ADDENDUM NUMBER 02

DATE: May 12, 2026

PROJECT: **CHEAHA STATE PARK FIRE STATION**

PROJECT NUMBER: **ASPD PROJECT #: 2026-005-16FS**

PROJECT NO: R08325001
 DATE: 04/17/2026
 SCALE: AS SHOWN
 SHEET NO:
A08.00
 REFLECTED CEILING PLANS

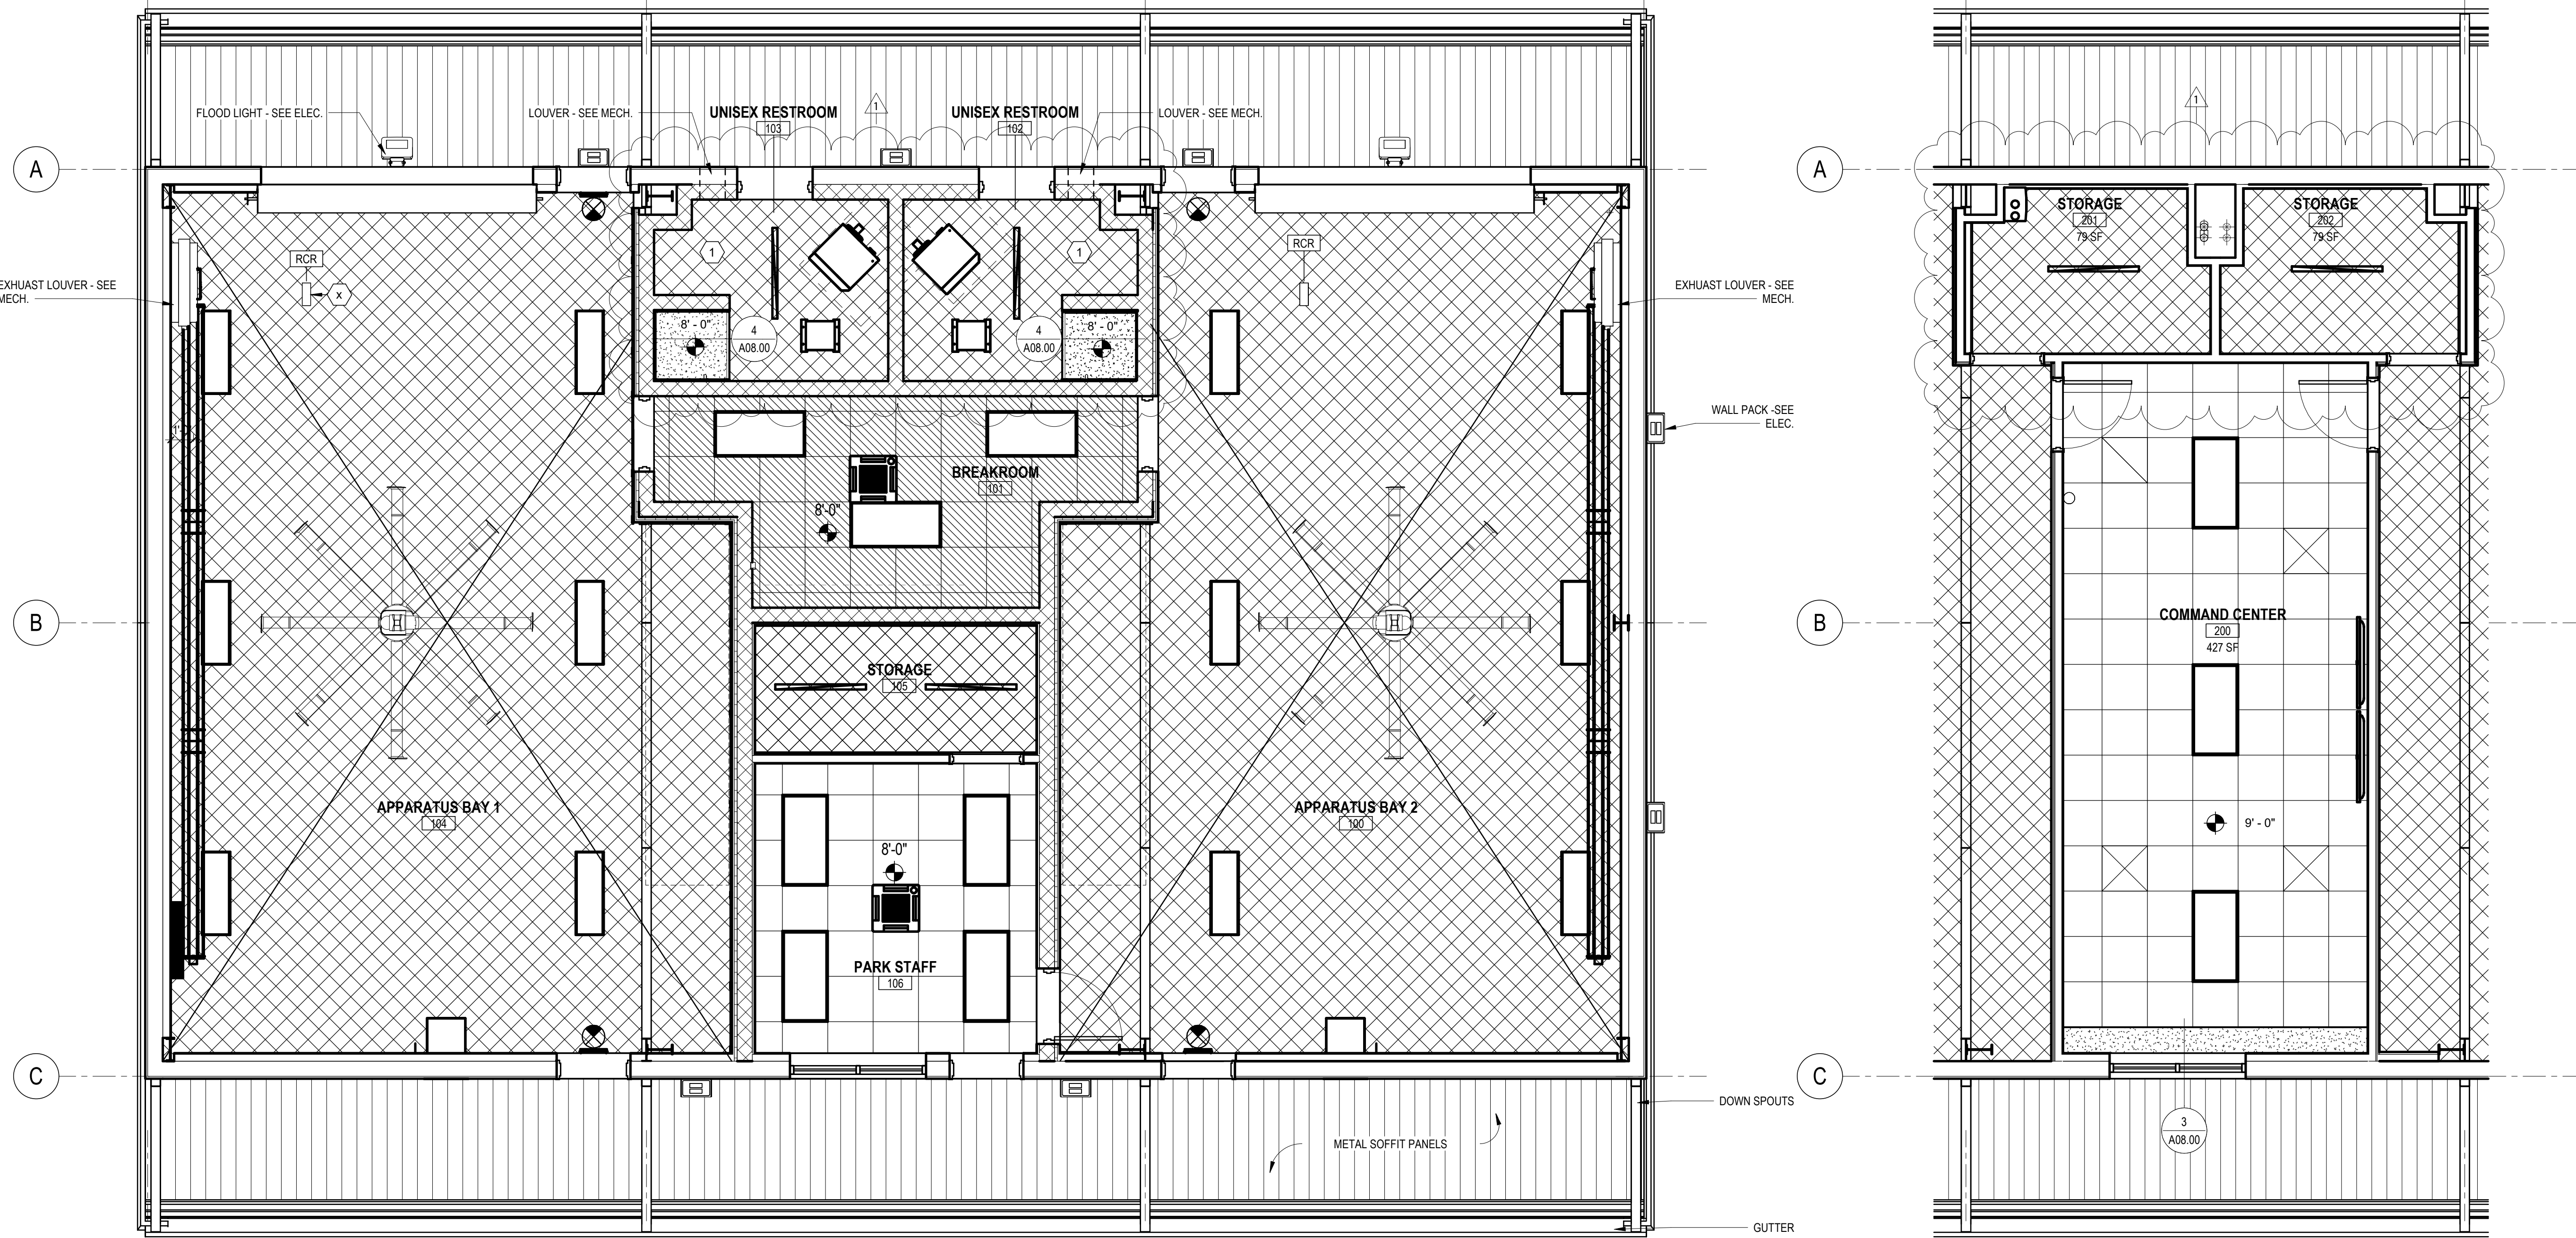
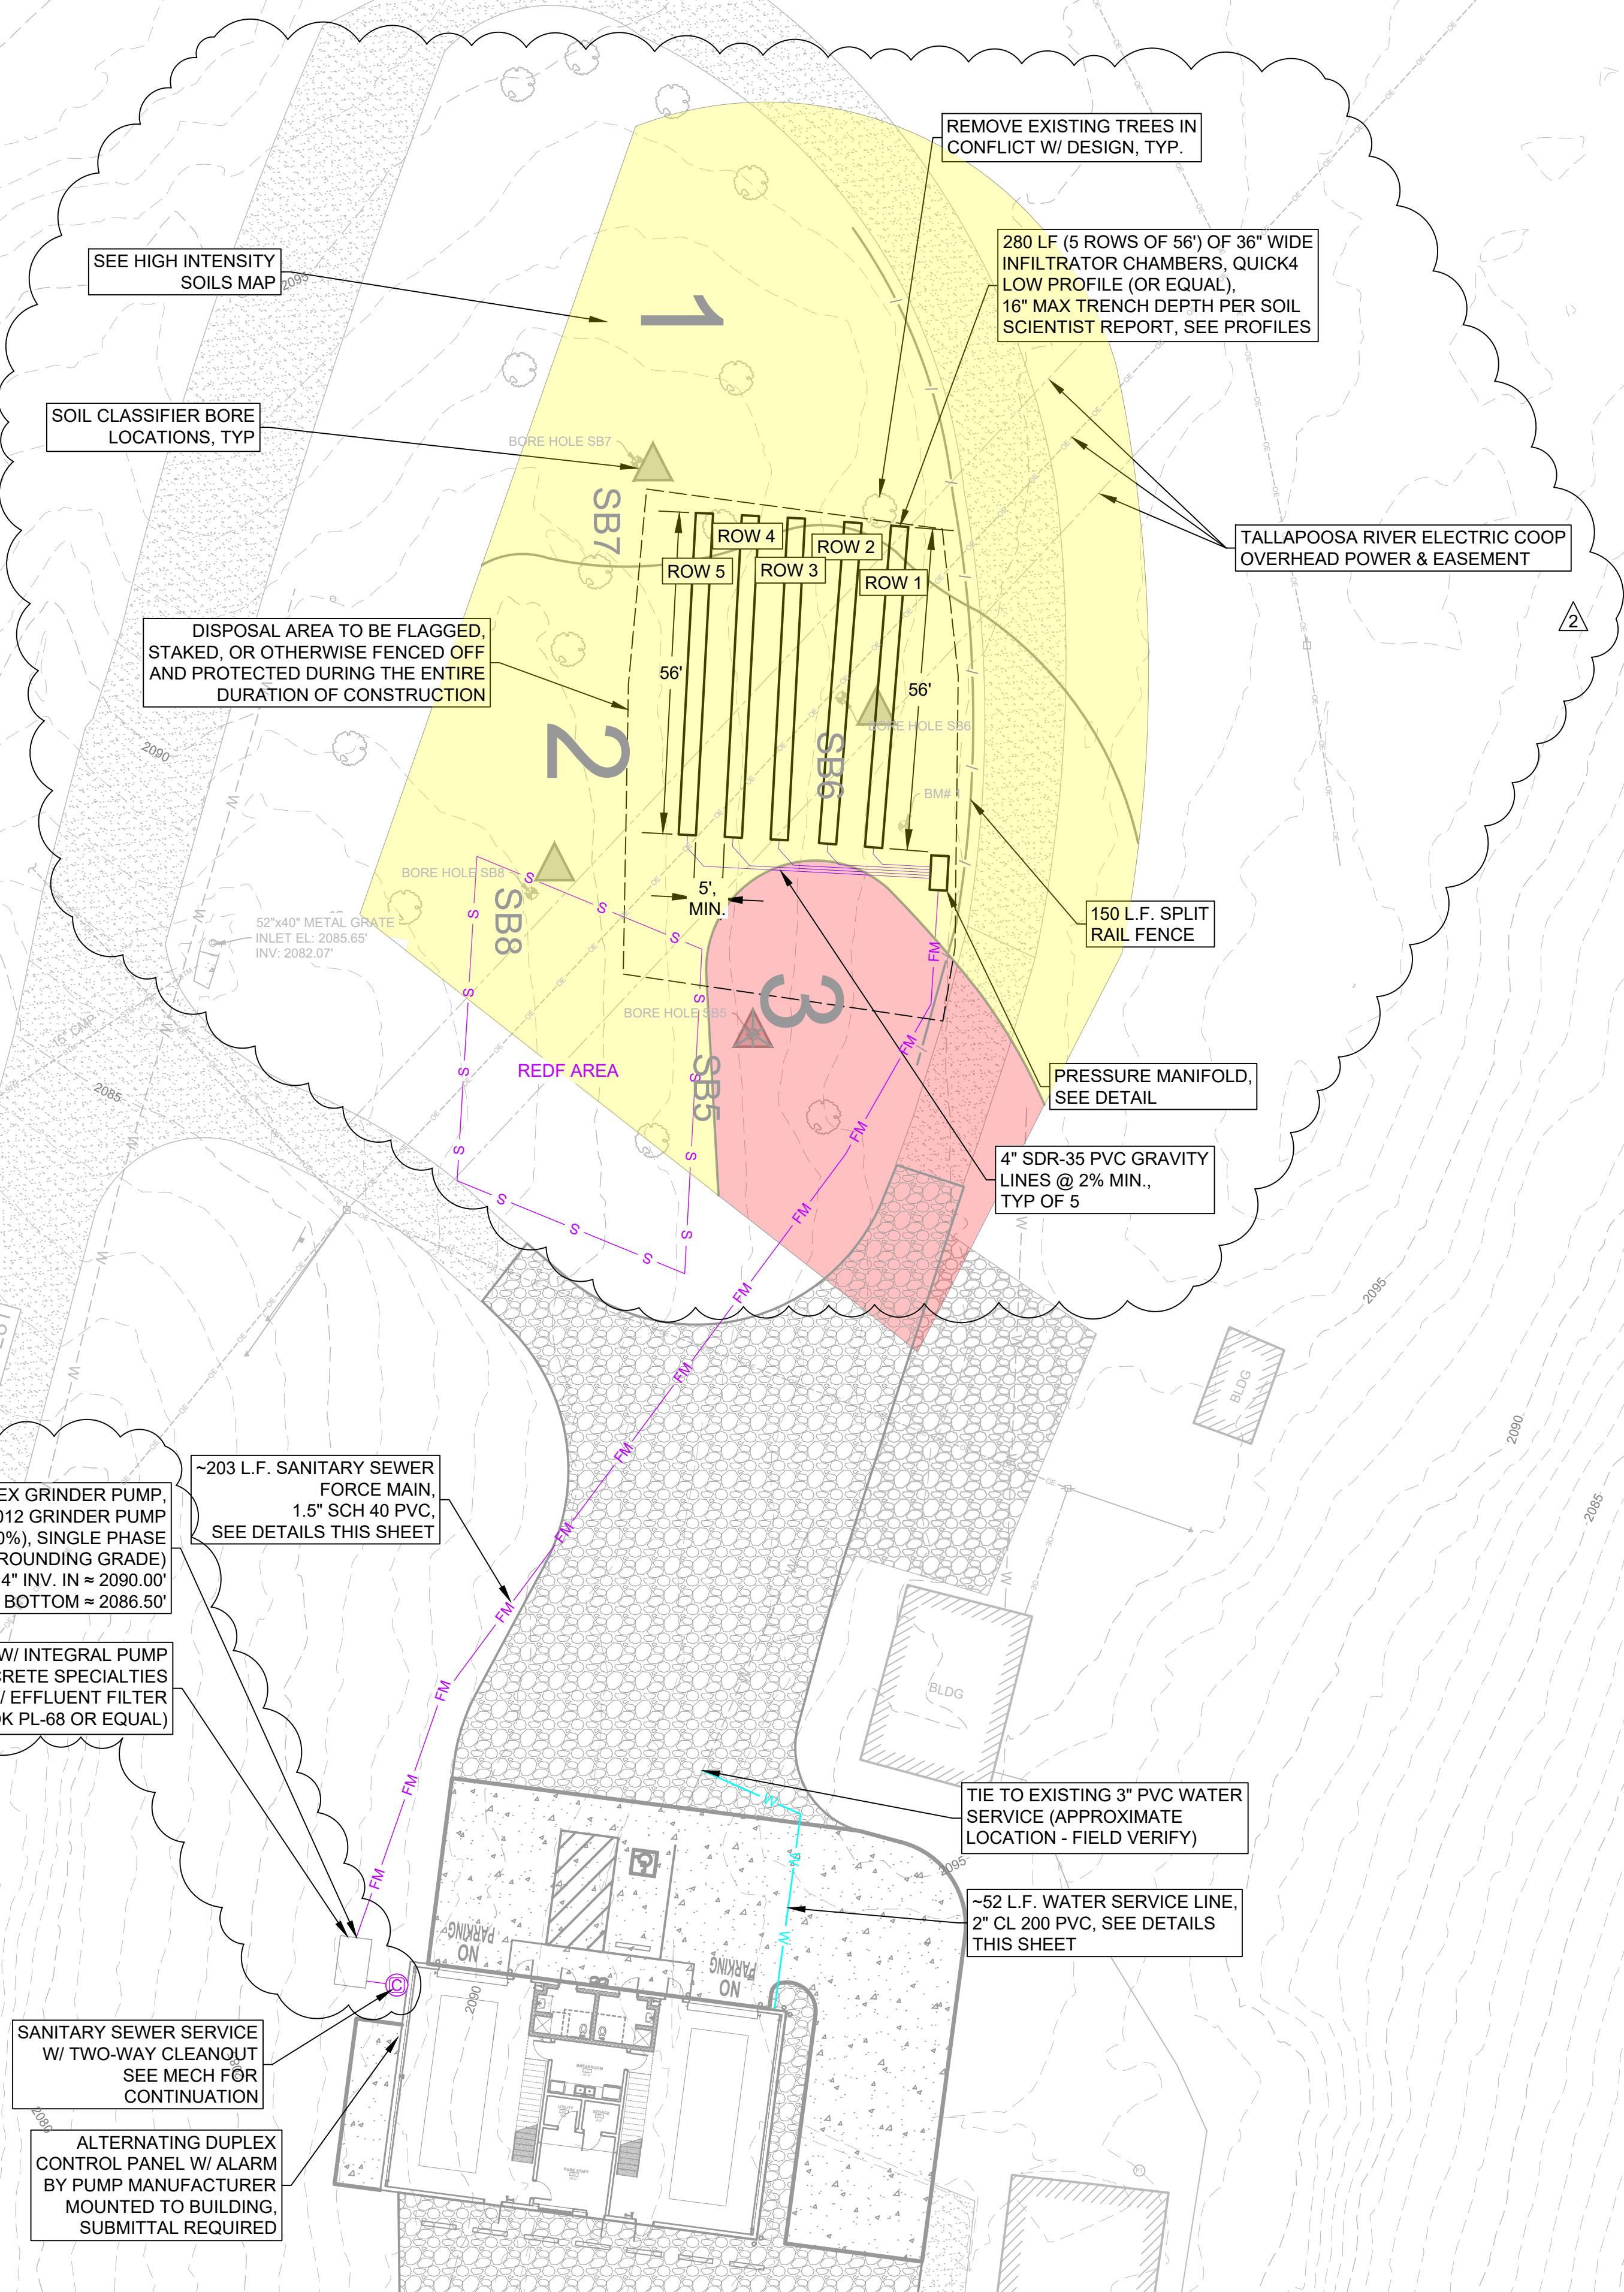
- a. Replace with the attached revised drawing.
 - b. Revision cloud reflects annotation correction.
9. **Sheet A08-00 – REFLECTED CEILING PLANS**
 - a. Replace with the attached revised drawing.

- b. Revision cloud reflects update light fixture layout in restroom.
10. **Sheet C-302A – UTILITY PLAN**
 - a. Replace with the attached revised drawing.
